Subject: FW: updated JVR project plot plan - Part 2 of 2 **Date:** Monday, April 12, 2021 11:40:03 AM

JVR ENERGY PARK

MAJOR USE PERMIT

OVERALL PLOT PLAN

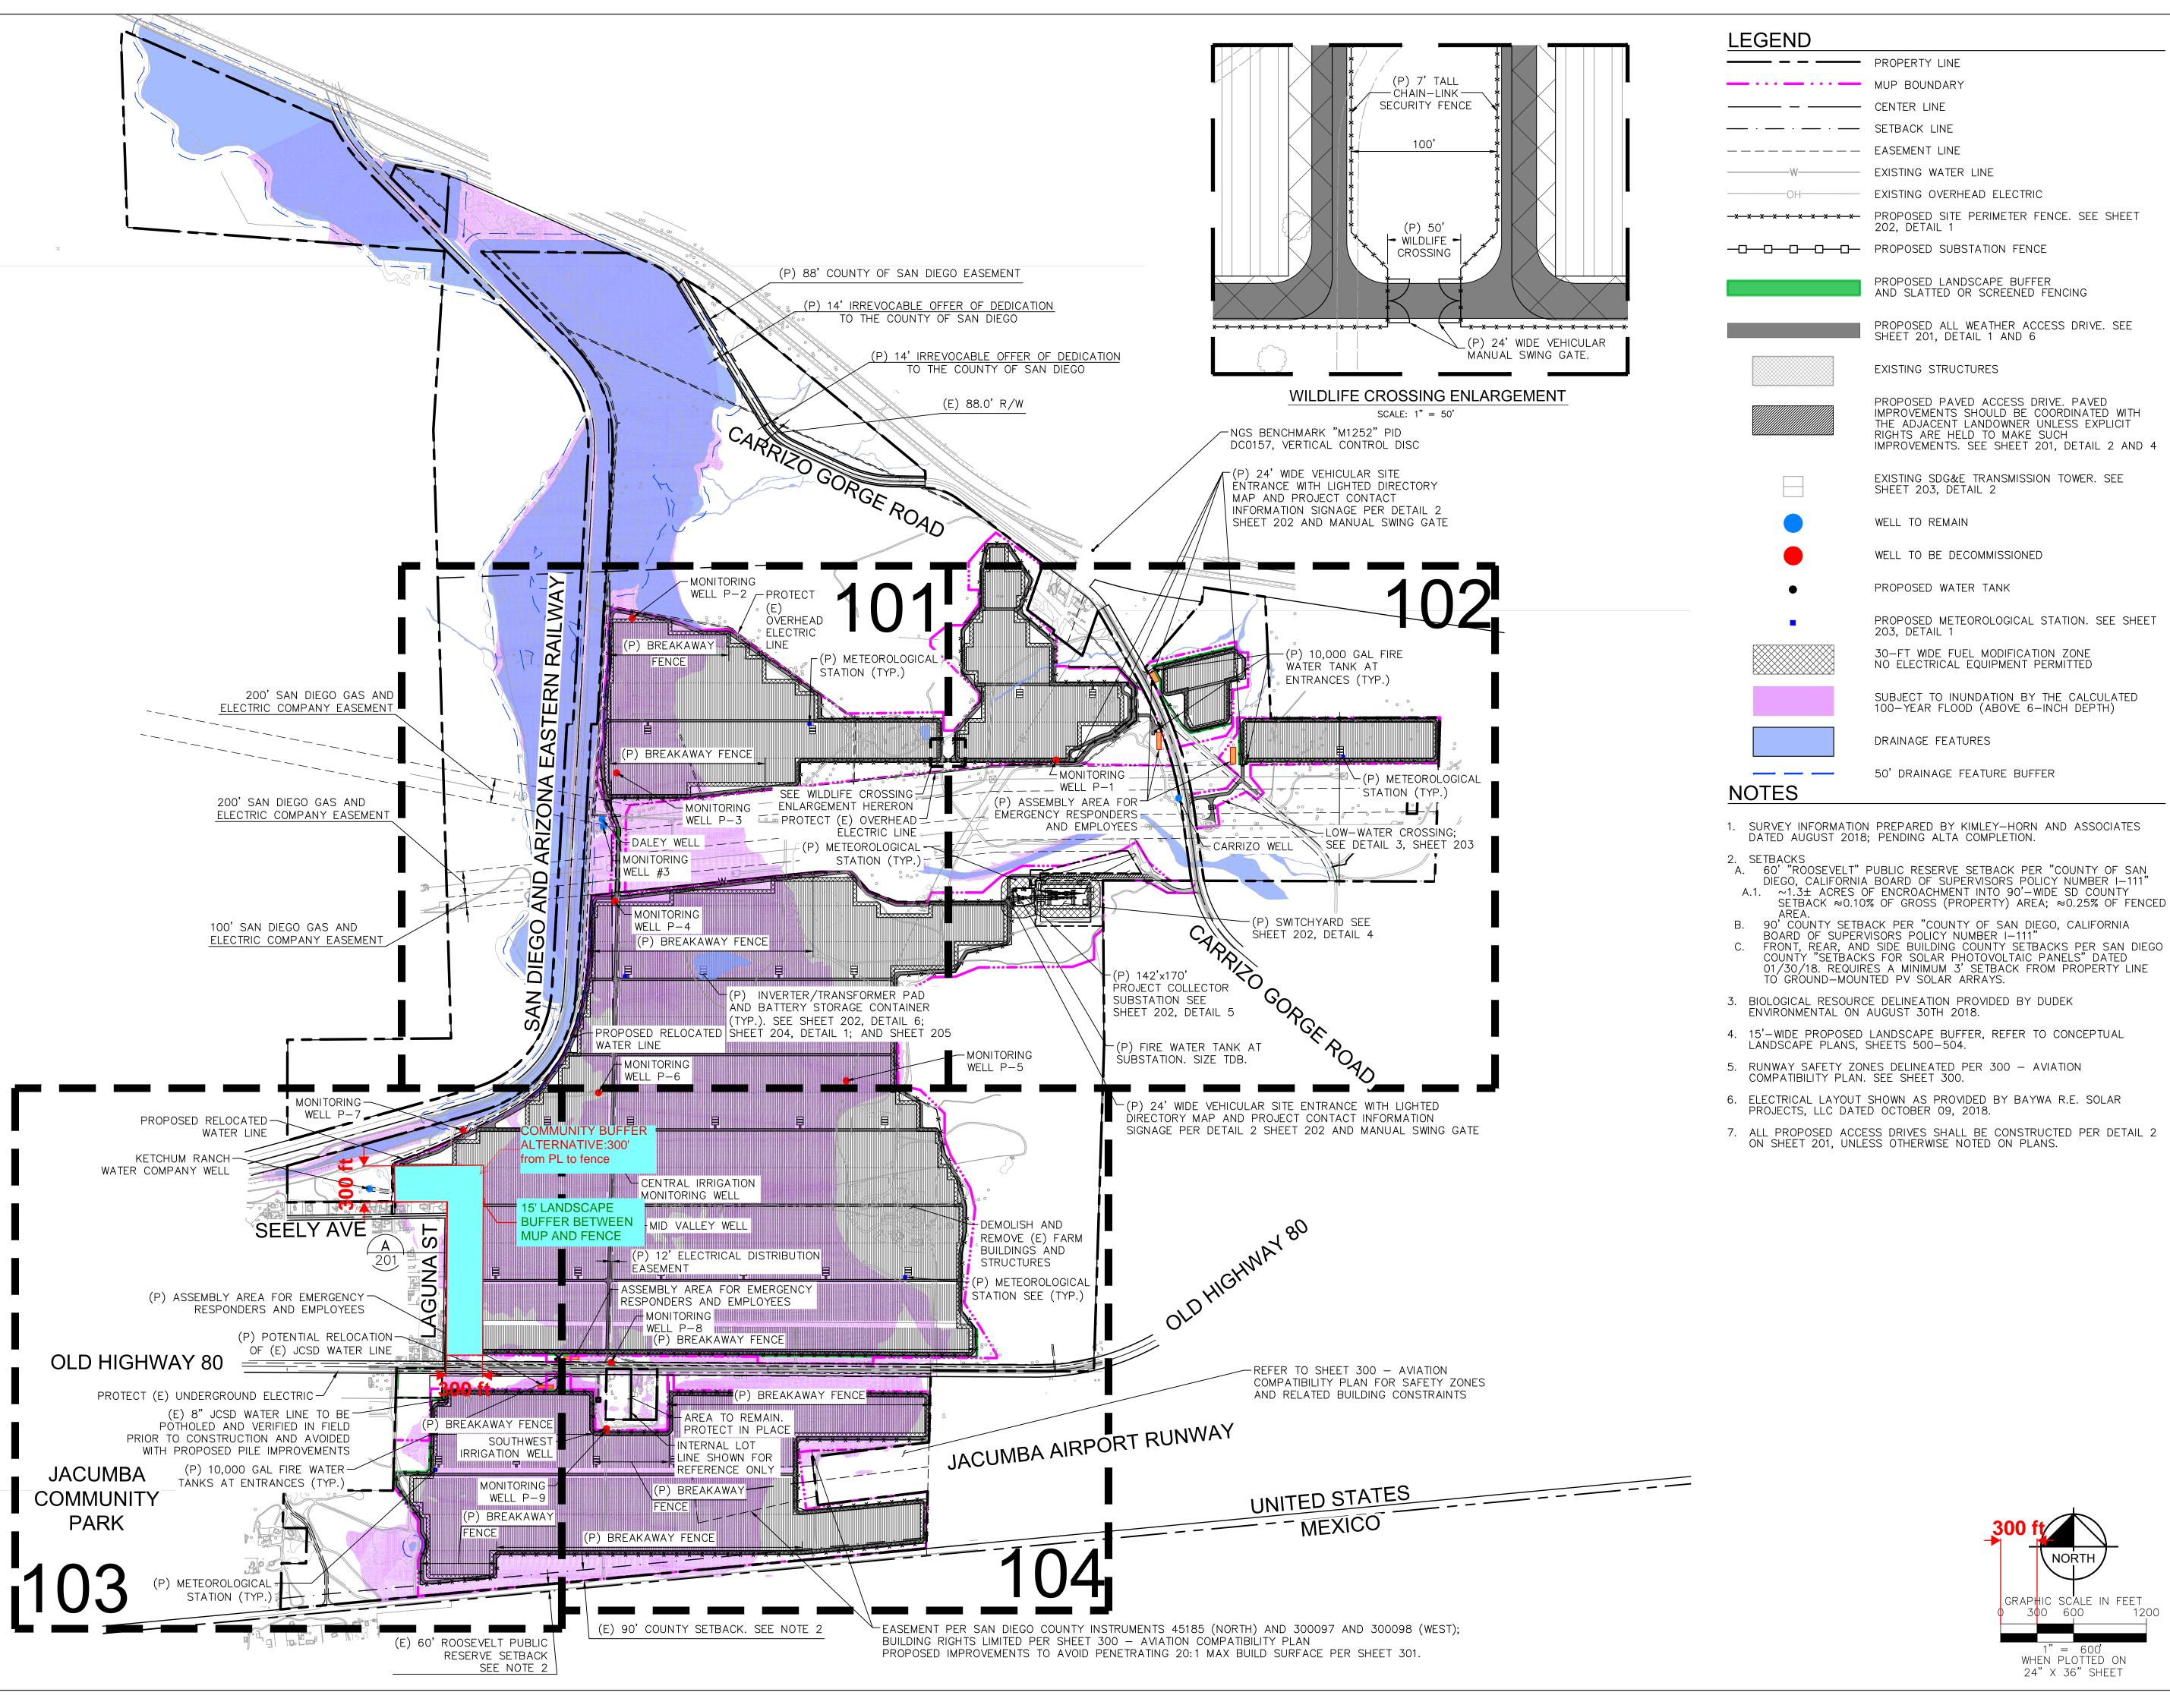
Major Use Permit Boundary: As a result of the increased setbacks described below, the size of the Major Use Permit area has been reduced from 643 acres to 623 acres.

Old Highway 80: Along Old Highway 80, the project fence line on both sides of the roadway has been set back further to provide a larger buffer between the roadway and the project. The fence line along the north side of Old Highway 80 will be 70 feet from the project property line to the fence line, providing a buffer to the north that is 52 feet more than shown in the previous plot plan. The fence line along the south side of Old Highway 80 will be 140 feet from the project property line to the fence line, providing a buffer to the south that is 122 feet more than shown in the previous plot plan.

Jacumba Community Park: Adjacent to the Jacumba Community Park, the project fence line has been set back further to provide a larger buffer between the park and the Proposed

Project. The fence line adjacent to the park will be 300 feet from the project property line to the fence line.

Water Main Realignment: The project will realign the water main north from the Ketchum Ranch Water Company well along the western edge of the project.
